Subject: AP1000 COL Response to Request for Additional Information (TR #3)

In support of Combined License application pre-application activities, Westinghouse is submitting responses to the NRC requests for additional information (RAI) on AP1000 Standard Combined License Technical Report 3, APP-GW-S2R-010, Rev. 0, Extension of Nuclear Island Structures Seismic Analysis. These RAI responses are submitted as part of the NuStart Bellefonte COL Project (NRC Project Number 740). The information included in the response is generic and is expected to apply to all COL applications referencing the AP1000 Design Certification.

Response to Request for Additional Information on Technical Report No. 3

Figure RAI-TR03-016-1

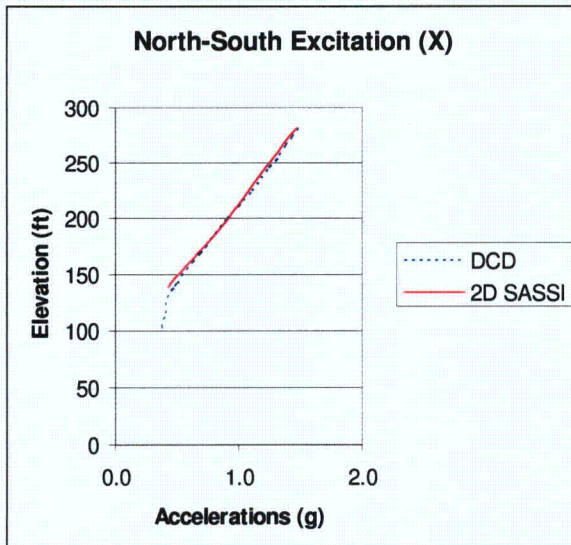
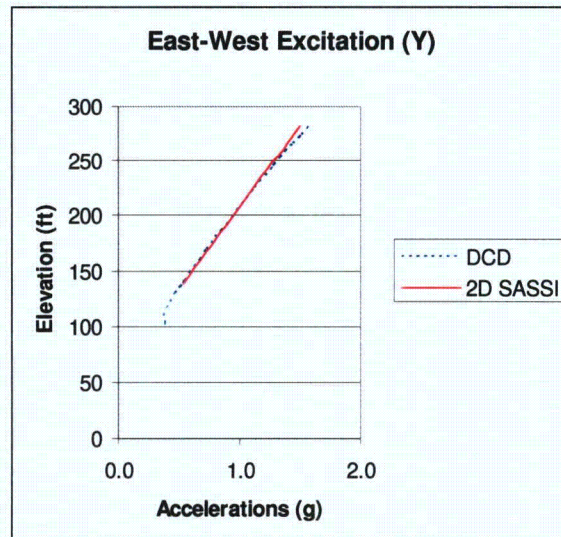
The first sentence of the fourth paragraph in Page 50 of 154 states that maximum member forces are shown in Figures 4.4.1-2 through 4.4.1-5. These figures indicate that the equivalent static analysis always results in highest member forces when compared with SASSI results based on other site conditions. The staff requests Westinghouse to identify which site condition was selected to develop the equivalent static acceleration profile used to perform the equivalent static analysis.

In addition, the staff's review of the report APP-GW-GLR-009, "Containment Vessel design Adjacent to Large Penetrations," found that the containment vessel was designed for seismic loads by applying equivalent static accelerations at each elevation based on the maximum acceleration from the fixed-base NI stick models tabulated in DCD Table 3.7.2-6. Based on the ZPAs shown in Table 4.4.1-2 and seismic loads shown in Figures 4.4.1-2 through 4.4.1-7, Westinghouse should demonstrate that the seismic loads used for the containment vessel design are the worst loading condition.

The equivalent static acceleration profile used in the parametric studies described in subsection 4.4.1.2 with member force results designated as EQ in Figures 4.4.1-2 to 4.4.1-5 is based on the maximum acceleration values obtained from the 2D ANSYS time history modal analyses of the same stick model on hard rock described in Section 7.1 of the report. These ANSYS analyses used the same model as the 2D SASSI analyses. The accelerations in Table 4.4.1-2, the member forces shown in Figures 4.4.1-2 to 4.4.1-5, and the floor response spectra in Appendix D are all from the 2D parametric analyses and are evaluated in the selection of the design soil cases as described in the fourth paragraph on page 50 of 154.

The equivalent static acceleration profiles specified for the design of the nuclear island structures are described in subsection 6.2 of the technical report. The accelerations for the design of the steel containment vessel given in Table 6.2-4 are generally lower than those used for the design of the steel containment vessel (SCV) which were based on the accelerations tabulated in DCD Table 3.7.2-6 (based on fixed base stick models). The comparison of these accelerations to the equivalent static accelerations defined from the time history analyses using the 3D finite element models and soil and hard rock cases (Table 6.2-4) are given in Figure E-3 in the technical report. The DCD Table 3.7.2-6 X (north-south) seismic accelerations envelope the maximum values obtained from the 3D finite element models. The places where the Table 6.2-4 values exceed the DCD Table 3.7.2-6 values in Y and Z direction are discussed in Reference 1. In this reference, section 2.5, it is stated:

In the Y direction the maximum envelope at elevations 131.68' is 3% higher than the stick model design value. This is not significant to the design of the containment vessel since the horizontal accelerations at elevations 100' and 169.93' are significantly lower than the design values.

In the Z direction the maximum envelope at elevations 100' and 131.68' are 15% higher than the stick models design values. This is due to the fundamental vertical mode of the nuclear island on the soil column; the greatest amplification occurs for the soft to medium soil. This is not significant to the design of the containment vessel since vertical seismic loads are a relatively small contributor to the shell stresses and horizontal accelerations are significantly lower for this soil condition.

The accelerations given in Table 4.4.1-2 of the topical report are from 2D SASSI analyses. Comparing these accelerations to those used for the design of the SCV, it is seen that they are similar. This is reasonable since the stick models used in 2D SASSI are based on the 3D stick models used for the results in DCD Table 3.7.2.6. This is seen in Figures RAI-TR03-016-1 and RAI-TR03-016-2 for the north-south and east-west directions. Therefore, it can be concluded that using DCD Table 3.7.2-6 acceleration values for the design of the SCV is conservative.

Figure RAI-TR03-022-1 – Deflection Plots of Shield Building for all Soil Cases

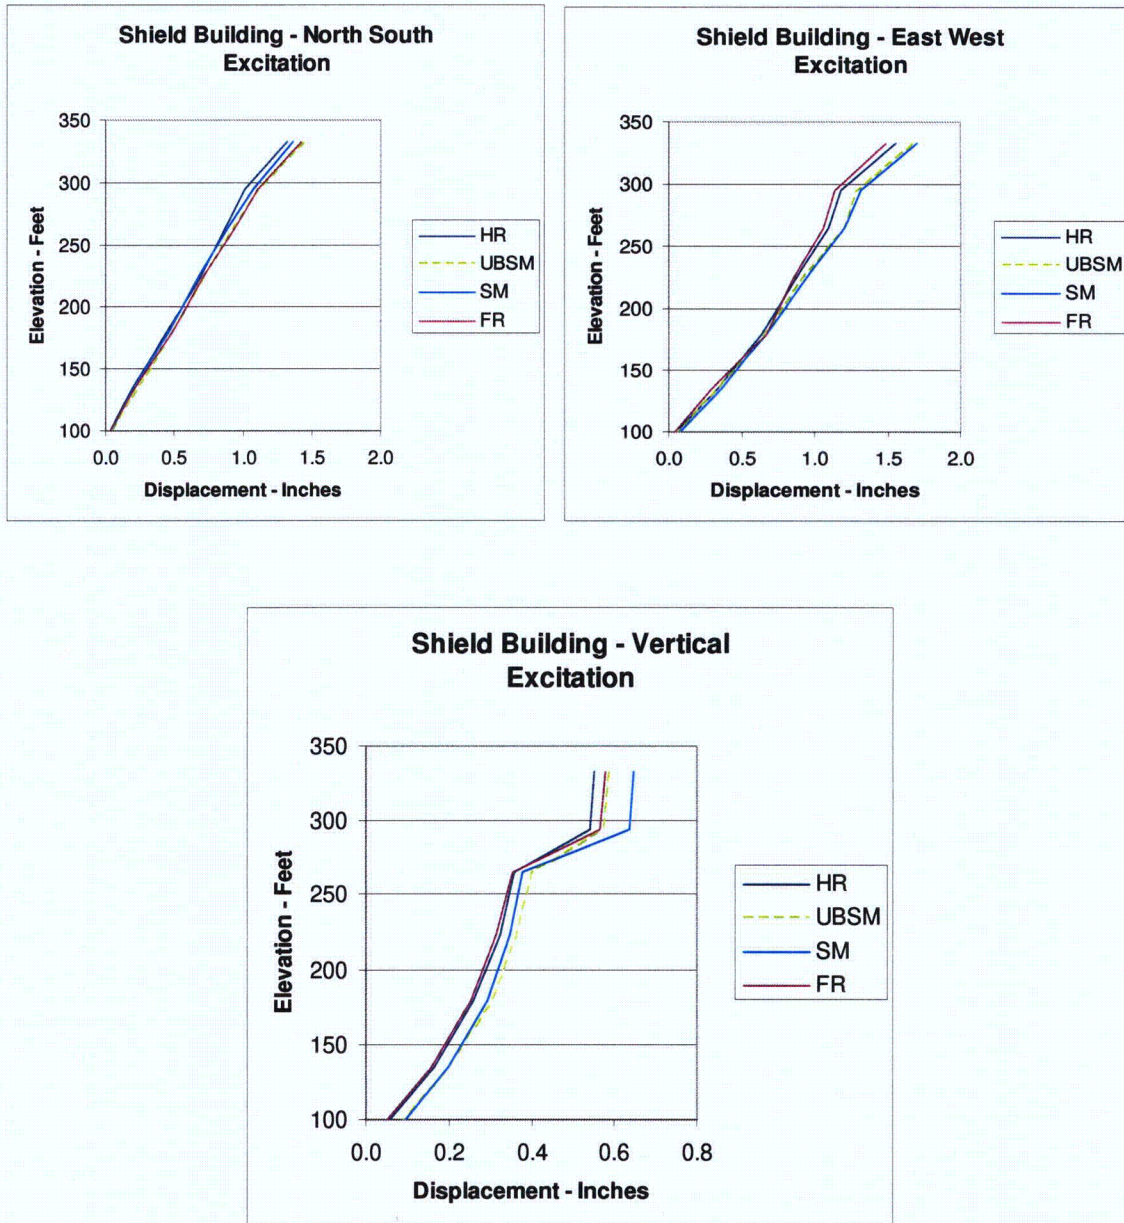
Section 6.3 states “The maximum seismic deflections that were obtained from the time history analyses and SASSI analyses given in Tables 6.3-1 to 6.3-3 for the auxiliary and shield building, containment internal structure, and steel containment vessel.” For the staff to properly evaluate this information, the following additional information is needed:

- a. Are the deflections in the tables a consistent set, based on the worst-case time history result, or are they an envelop of maximum deflections from all the time history results?
- b. How do these tabulated deflections compare to the corresponding deflections obtained from the equivalent static acceleration analyses? Please provide a tabulated comparison, and an explanation of any significant differences.

The deflections given in Tables 6.3-1 to 6.3-3 are the envelope of maximum relative deflections from all of the time history results for the soil and hard rock cases. Displacements at different nodes for the soil cases have been obtained relative to the translation of a reference node at the bottom of the foundation and near the center of the basemat. Coordinates of this reference node are $x= 993.00$ ft, $y= 986.00$ ft and $z= 60.50$ ft. Deflections for the hard rock case are relative to the fixed base at foundation level. The deflections given in these tables have been revised to remove drift. To calculate the displacement relative to basemat, a baseline correction is made by adding a small constant acceleration to the response acceleration at every time step for the first 0.05 seconds of the time history. If baseline correction is not performed, a residual drift in displacement time histories will be obtained at the end of the seismic excitation. After adding the small constant acceleration to the acceleration time histories, displacement time histories calculated have zero displacement once the seismic excitation has finished. See Tables RAI-TR03-022-1 to RAI-TR03-022-3 that provides the revised relative displacements.

Figures RAI-TR03-022-1 and RAI-TR03-022-2 show the maximum deflection plots for the shield building and steel containment vessel for each of the soil cases. As seen from the tables above the maximum deflections envelop all of the soil cases. These structures have fairly uniform cross section. The containment internal structures and auxiliary building are less uniform in cross section and in some cases deflections at a lower elevation are higher than that at a higher elevation. This is due to cases like the edge of the CIS operating floor having a higher deflection than the displacement of a steam generator or pressurizer compartment at a higher elevation. To show that the deflection behavior is reasonable, Figures RAI-TR03-022-3 and RAI-TR03-022-4 show deflections for the NW corner of the pressurizer compartment and the SE corner of the East steam generator compartment. On these plots the nodes at and above the operating floor are at similar locations in plan; the node at elevation 99 is at the center of the containment.
